SUBJECT Trinity Parkway Technical Proposal
(Conceptual Development of the Design Charrette Report)

Trinity Parkway Technical Proposal

(Conceptual Development of the Design Charrette Report)

Transportation and Trinity River Project Committee
March 21, 2016

Variation #1

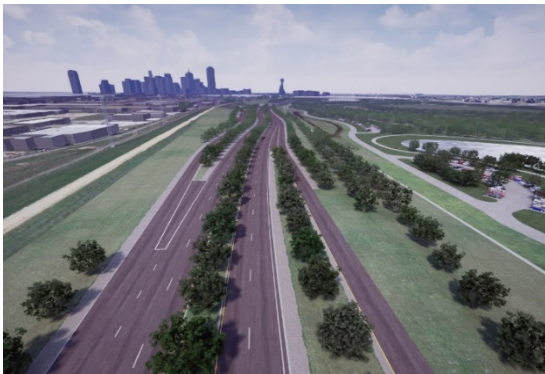
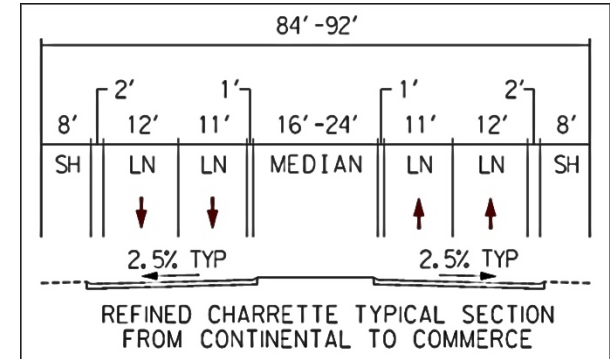
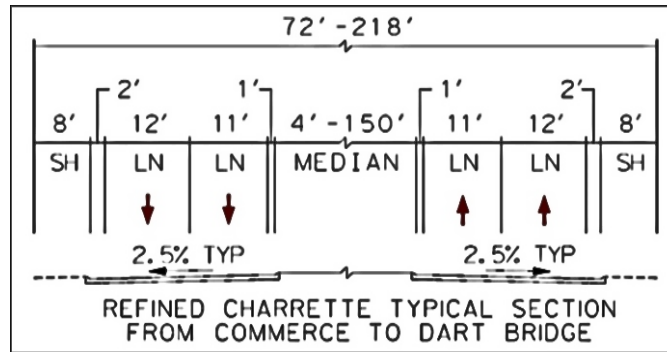
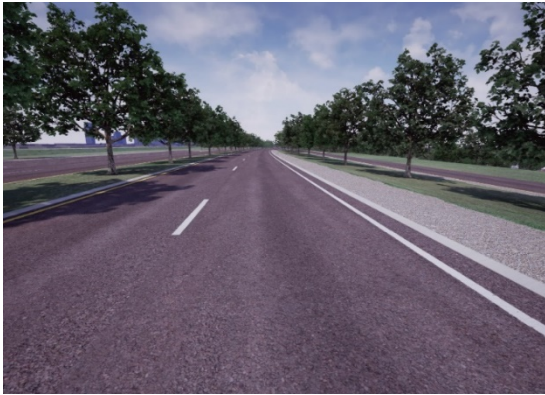
Only build a 4 lane roadway now – fit those 4 lanes of traffic (narrower lanes + grass shoulders) meandering within the approved road corridor.

***Technical Team Findings:** The Technical Proposal is generally consistent with the Design Charrette Team vision and several elements further reinforce that vision. Regarding the ROD, the Technical Team understood that design exceptions would be required from the approved scheme and these would be suggested as part of a staged approach. Lane widths were meant to be those of a standard arterial roadway. This is likely acceptable for a first phase as a meander within existing road alignment. Reduced lane width and minimized shoulders may require design exceptions.*

Variation #2

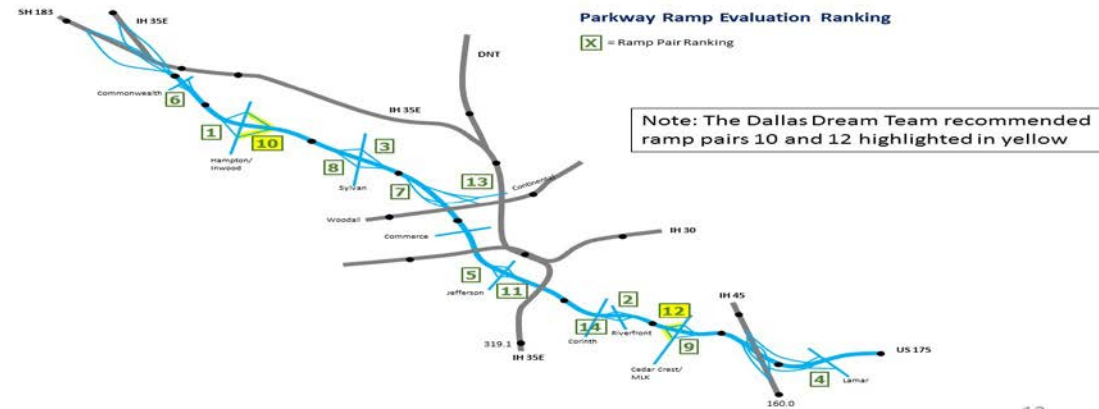
Build fewer ramps. Only build two set of ramps within the park accessing the inner city for the foreseeable future: 1 on/off pair at the north end near the Medical District and 1 on/off pair at the south end near Cedar Crest.

Technical Team Findings: The Technical Proposal, even with its variations, generally meets the intent of the Design Charrette Team vision, provided that one intrusive ramp at Riverfront is relocated if shifted from Cedar Crest. Vehicle Miles Traveled (“VMT”) projections were generated for each proposed intersection in the ROD, as well as the recommended interchanges by the Design Charrette Team. Design exceptions would likely be required from the approved design for fewer ramps, and to shift and reconfigure ramps. The initial two sets of ramps or interchanges are recommended as part of a first phase.

Variation #3 & #4

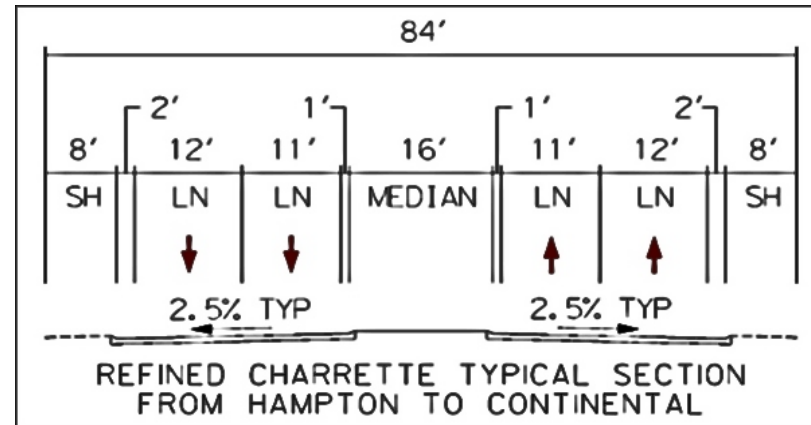
Ban trucks except for emergencies; Add a U-turn option within the Parkway corridor at mid-point.

***Technical Team Findings:** There is nothing in the Technical Proposal that would forestall adoption of a policy to ban trucks, but this decision will require further assessment with project partners to determine potential financial implications. Regarding U-turns, Corps guidance would be required from the approved scheme and these would be included as part of a phased approach.*

Design Refinement #1

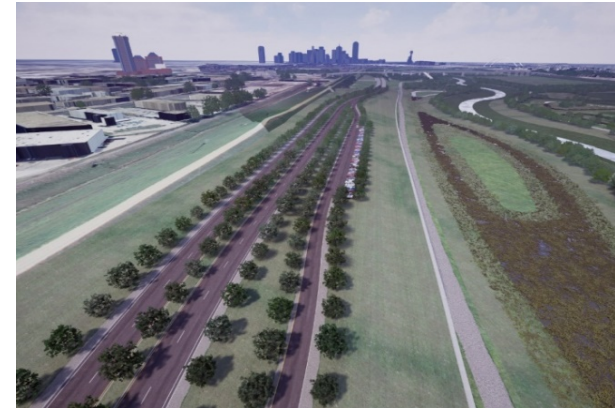
Meander the Parkway within the approved road corridor so that future road sections can be finished now as pull-off parking areas on both sides of the Parkway – for park access and scenic overlook.

***Technical Team Findings:** Design exceptions may be required from the approved scheme to achieve the pull-offs and parking for park access. These would be suggested as integral to the staged or phased approach because these pull-off/parking paved areas are all located within areas that may ultimately be paved as part of a full build out as currently approved in 3C.*

Design Refinement #2

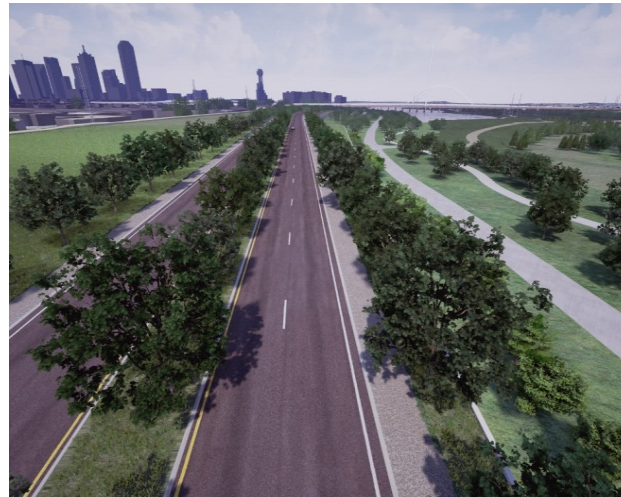
Design refinement of the landscape configuration to add a consistent linear tree pattern at about 20' – 40'-centers along the Parkway – making it a “Tree-Lined Parkway” for character and beauty.

***Technical Team Findings:** The Technical Proposal is generally consistent with the Design Charrette Team vision to achieve the experience of a roadway lined with trees. This potential configuration of a tree-lined Parkway remains contingent upon the 65%-level landscape design development when the full detailed landscape plan is further refined. This will include additional hydrologic review that is consistent with the Corps' technical parameters.*

Section M: North of Houston Street Viaduct looking South
1247+00

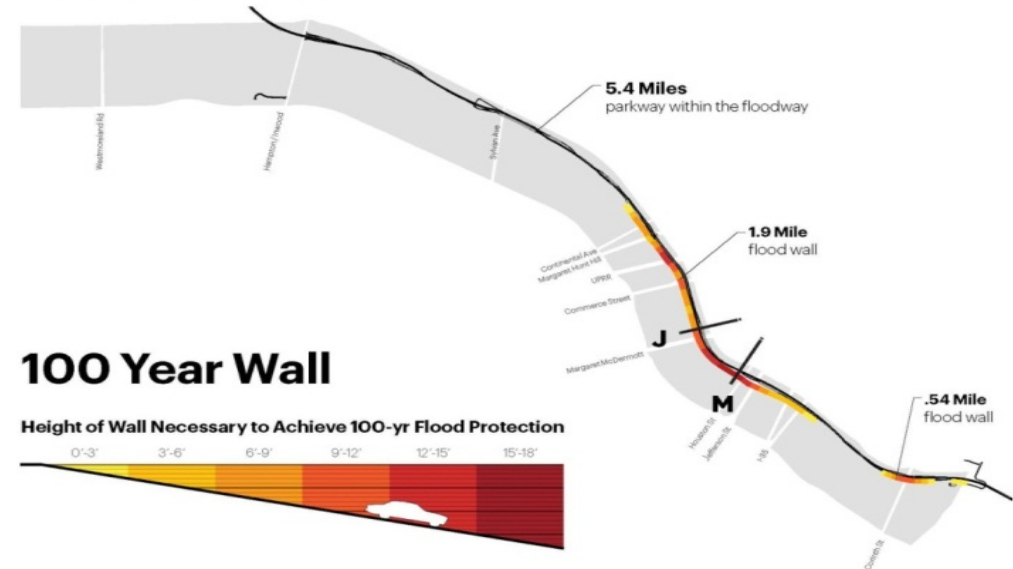
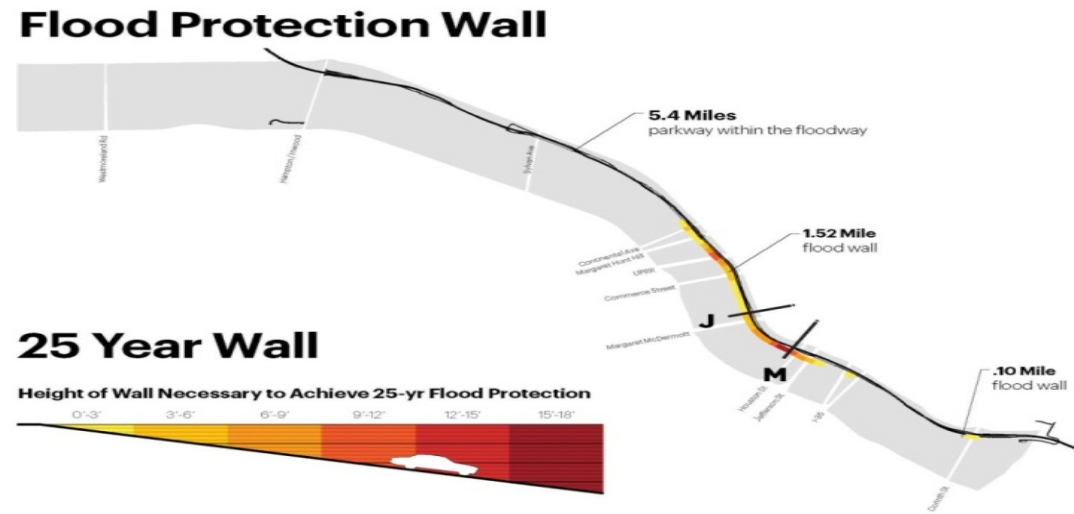
Design refinement of flood protection barriers with landscape, art, wall treatments and hillocks or berms to eliminate blank walls and secure more pervasive views of the park and to add character, interest, and a strong ecological strategy all along the Parkway.

Technical Team Findings: Design exceptions will be required from the approved scheme to achieve berming on the Parkway side for the 100-year flood standard. Further detailing of this concept with landscape elements may be pursued during the 65%-level landscape design development. Resolution of berming on the park side of the wall cannot be determined until the full park review is undertaken because more solutions may be necessary to meet Corps hydrologic requirements. Pursuing a flood standard of less than the 100-year protection will almost certainly challenge the ROD, representing a high risk in moving the project forward. The Technical Team's recommendation is to uphold the use of the 100-year flood standard for the Parkway.

Design Refinement #5

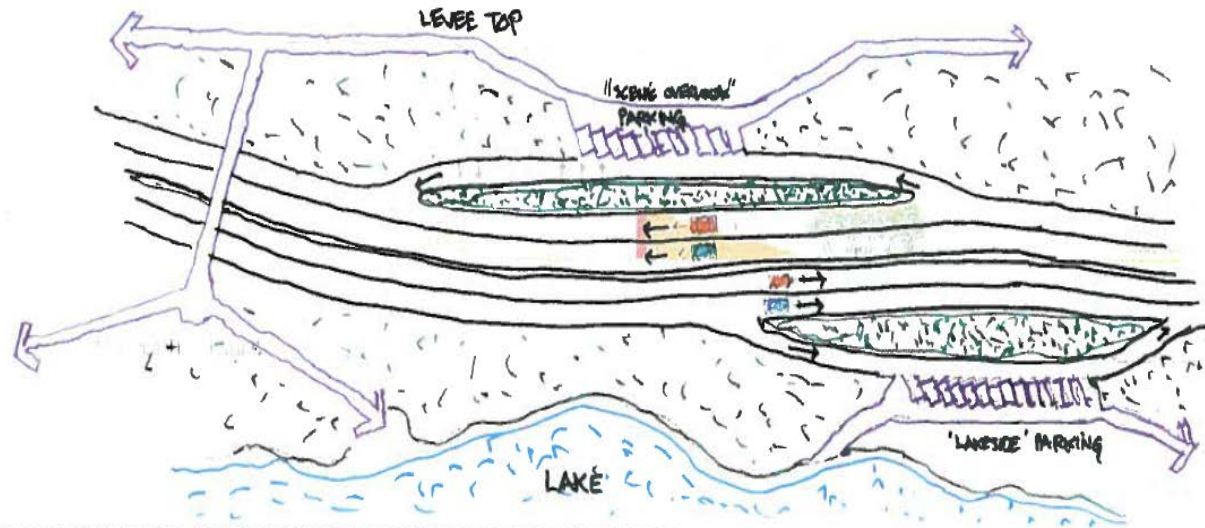
Design refinement to exploit five major “WOW” views over the Parkway.

***Technical Team Findings:** This idea is consistent with the ROD, although design exceptions may be required to achieve pull-off parking areas as part of a phased or staged approach.*

Design Refinements #6 & #7

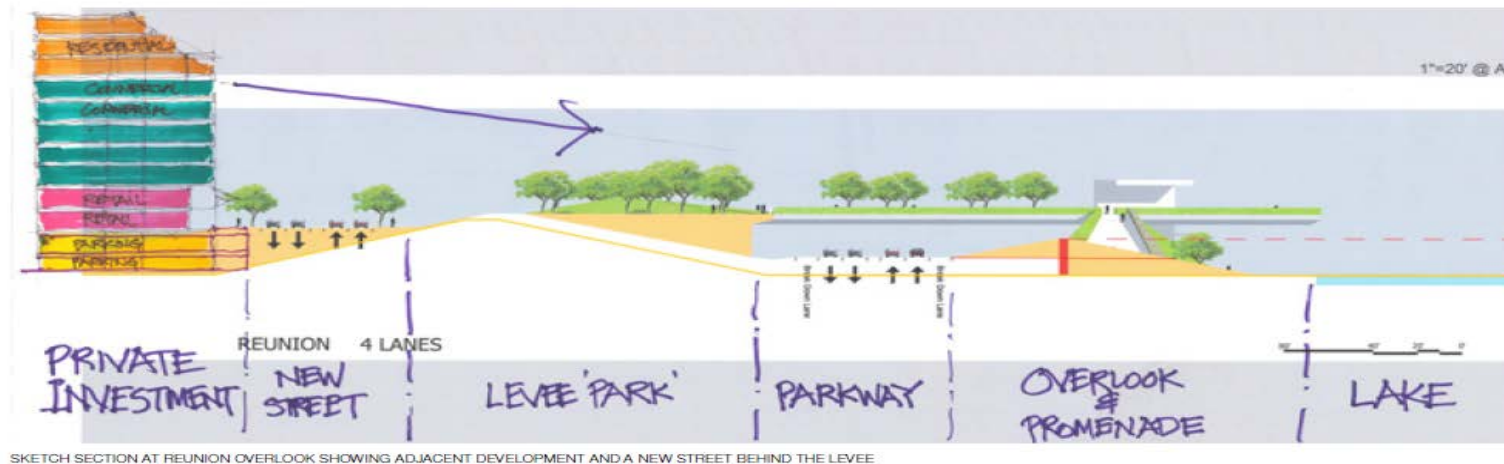
Allow toll free park use from the Parkway; Locate transit stops so as to enhance transit-user access to the park over the Parkway – for example, provide a Houston Bridge streetcar stop and a Riverfront Boulevard bus stop.

***Technical Team Findings:** There is nothing in the Technical Proposal that would forestall adoption of this policy decision to allow toll free use of the park. This will require a policy decision among project partners related to operation of the roadway, with the need to confirm financial implications. With regard to transit user access, this opportunity is not ruled out by the current Technical Proposal. This should be resolved with further design.*

Development Strategy #2

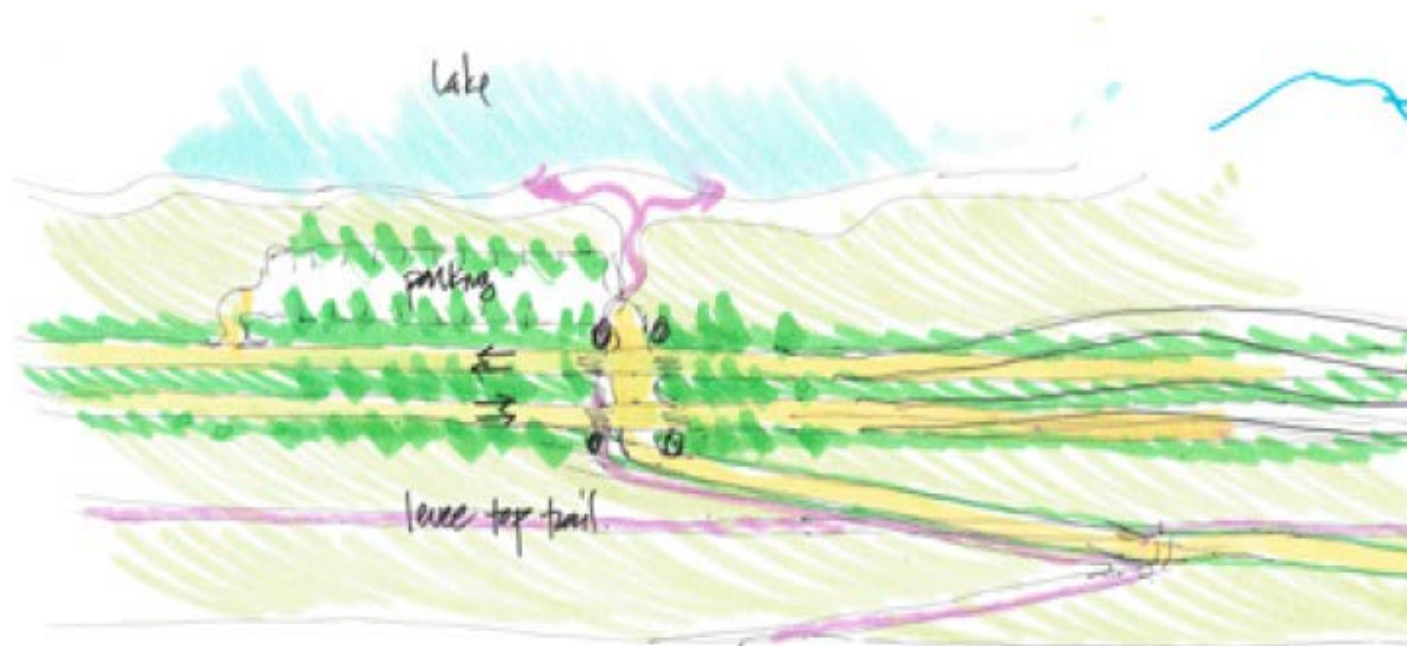
For the 'Design District', facilitate the current incremental development trend with regular and attractive pedestrian connections across the Parkway to the park.

Technical Team Findings: The Technical Proposal confirms the Design Charrette Team vision for this development strategy. This will be further explored as part of the park review process now underway.

Variation #1

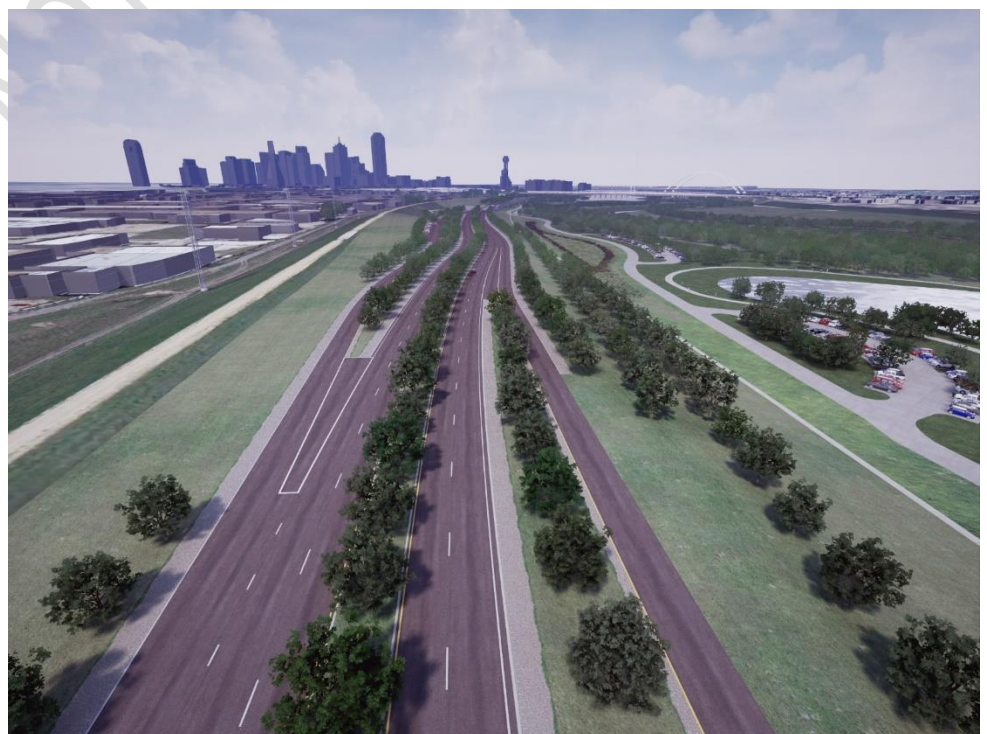
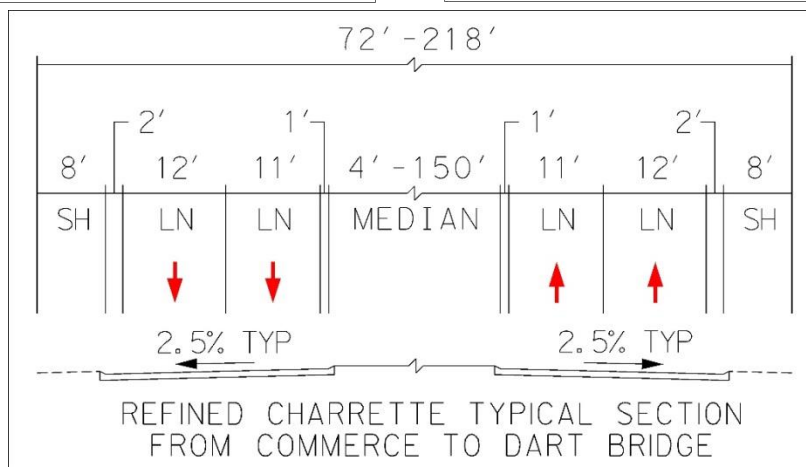
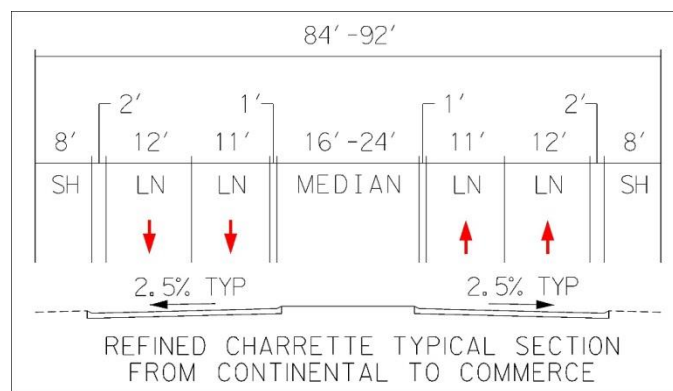
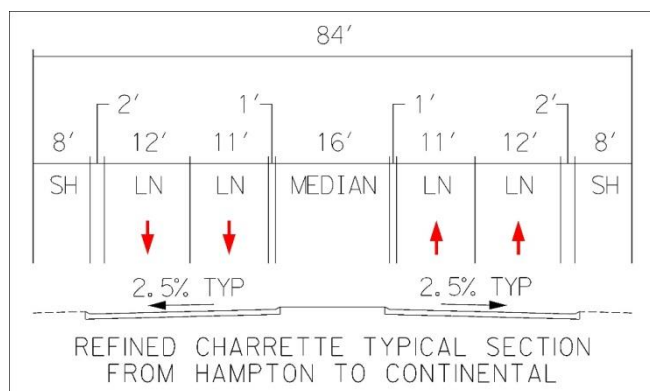
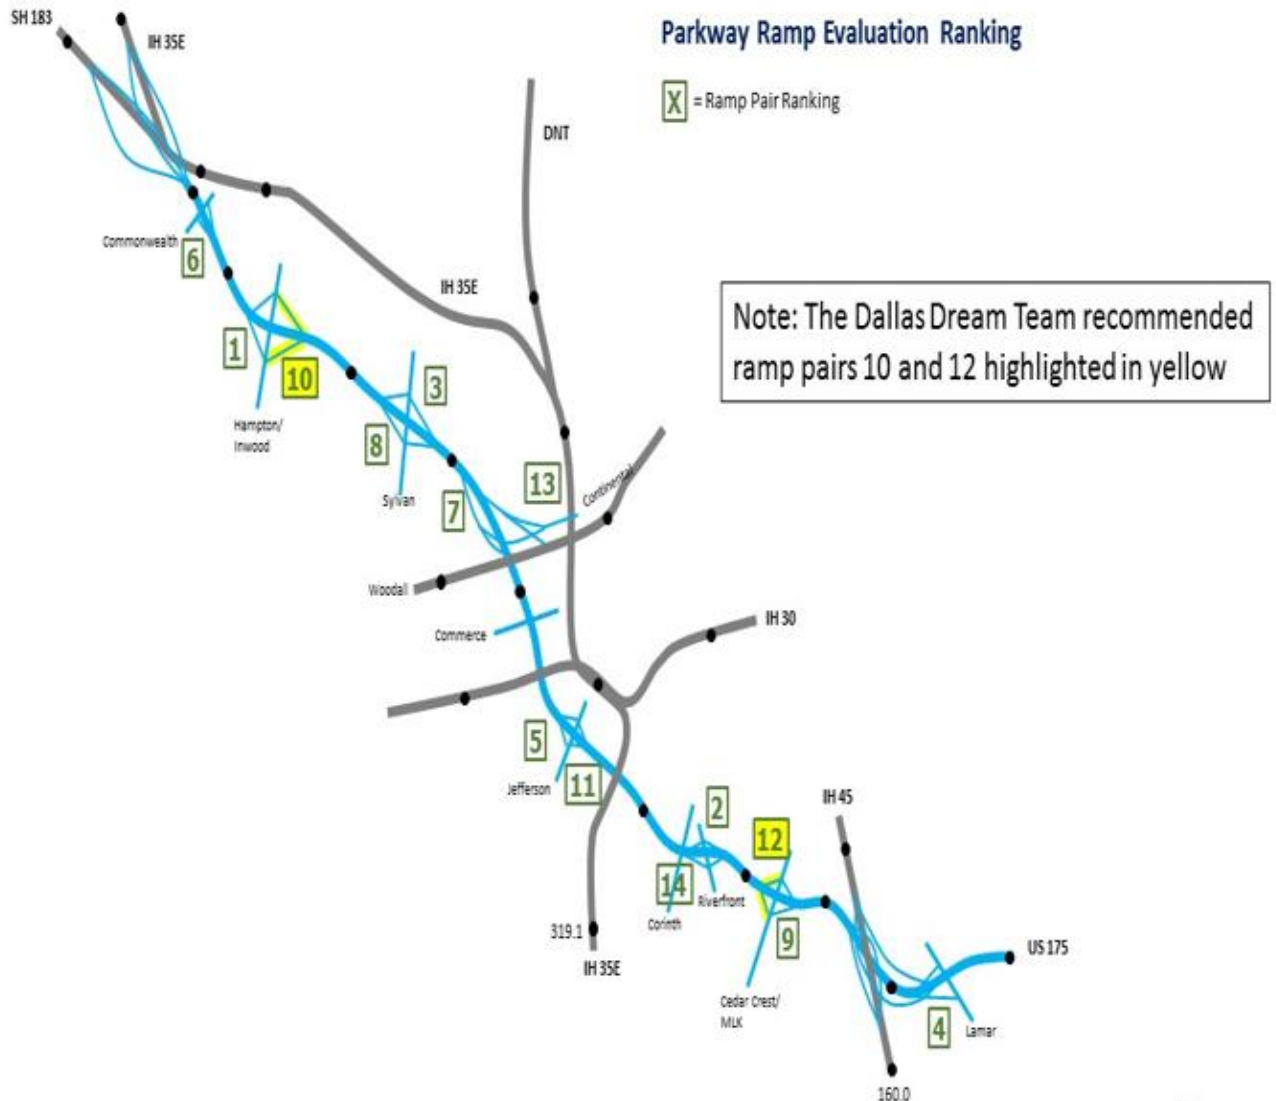
Only build a 4 lane roadway now – fit those 4 lanes of traffic (narrower lanes + grass shoulders) meandering within the approved road corridor.

Discussion: The Design Charrette Team further clarified that the meanders would be sufficient within the proposed road corridor without the need to extend beyond the corridor to a footprint encompassing other parts of the bench areas. It was affirmed that the Design Charrette Team wanted to avoid neutralizing more areas on the bench which would be useable for park activities or ecological landscape. Thirteen (13) meanders were confirmed. The decision was made to pursue the most purposeful meanders to exploit key views and offer a more aesthetically pleasing driving experience. It was also explained that meanders were not expected where bridge structures are currently clustered.

The Technical Team also spent time discussing the desired lane widths, shoulder treatment, and the median width variables. Regarding the potential for 4 lanes, the Technical Team determined this configuration was likely acceptable for an initial stage. However, staging must not preclude construction of ultimate design approved in ROD. The potential for a median was discussed and the Design
